Richgro Garden Products

*Noise Regulation Technical Advice: Richgro Garden Products –
203 Acourt Road, Jandakot – Acoustic Assessment*

Richgro Garden Products, Jandakot

Groundwater quality issues and potential sources of contamination

Figure 2. Variation of ammonium nitrogen concentrations (in mg/L) with time in water supply production bore J130

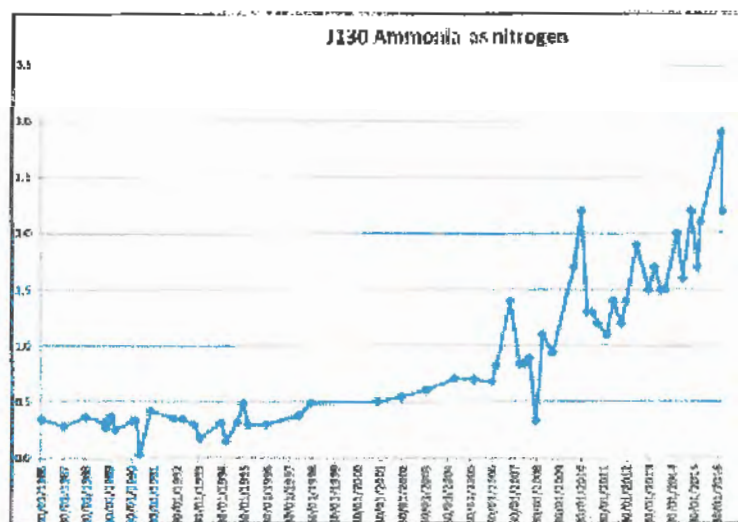
Figure 2 indicates that periodic concentration peaks of ammonium have occurred in bore J130 that are superimposed on a trend of increasing background concentrations of this chemical constituent in groundwater. These concentration peaks may be due to seepage from the Richgro site, but in practice it would be difficult to distinguish between potential sources of ammonium ions for groundwater in the vicinity of bore J130.

Figure 1. Water table contours (elevations in mAHD) in the vicinity of the Richgro site from the Department of Water online Perth Groundwater Map. Groundwater flow directions at the water table are indicated by arrows.

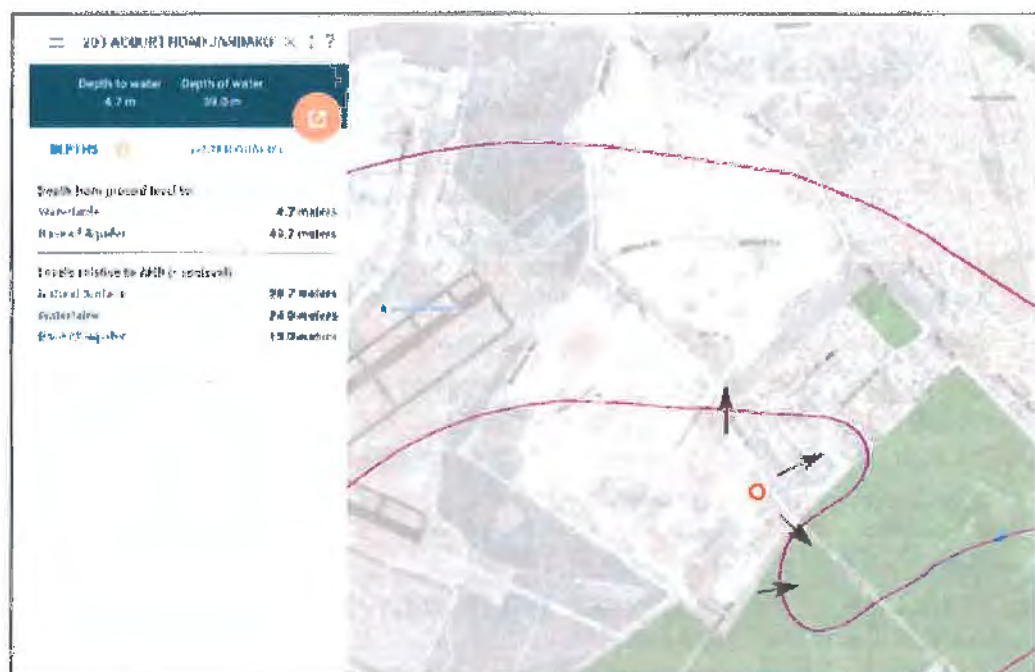
However, assuming that the water table contours shown in Figure 1 are representative of the current groundwater flow regime in the area, the Richgro site appears to be located on a local groundwater flow divide where groundwater near the water table on the western half of the site flows in a general northerly direction, whereas shallow groundwater on the eastern portion of the site flows in a north-easterly to south-easterly direction. This variability in groundwater flow directions is likely to have a significant effect on the viability of the current network of groundwater monitoring bores on the Richgro site, as there do not appear to be sufficient bores present on the site to monitor transport pathways from potential sources of contamination at the site.

Figure 3. Hydrographs from Department of Water monitoring boreholes showing the seasonal range of water table elevations on the northern part of the Jandakot Mound.

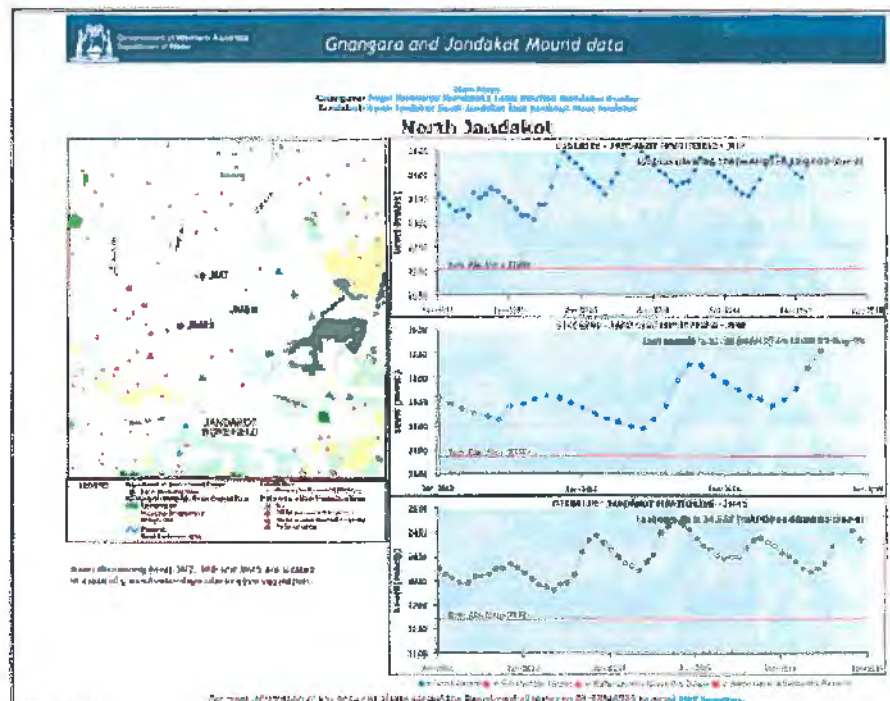
Hydrographs from Department of Water monitoring bores in the vicinity of the Richgro site (Figure 3) indicate that the height of the water table in the area varies seasonally by about 1.0 to 1.5 metres, although this varies from year to year depending on annual rainfall and on the distribution and magnitude of groundwater abstraction in the area. The highest water table elevation usually occurs in September-October each year, whereas the water table reaches its lowest point in April-May each year.

It is understood that measured water levels measured in bores near the main pond on the Richgro site varied in depth between 3.5 metres to 4.2 metres below ground between June 2016 and January 2017 respectively. Given that these water level measurements were made at times when the water table is not at its lowest and highest point, and given the seasonal range of hydrographs shown in Figure 3, it is possible that the seasonal highest water table elevation near the main pond on the Richgro site is up to 30 cm higher than measured and the seasonal lowest water table elevation is up to 30 cm lower than measured. This would suggest that the pond liner at the base of this pond is located below the water table for up to a six month period each year and that in September-October each year the pond base could be up to 0.8 metres below the water table.
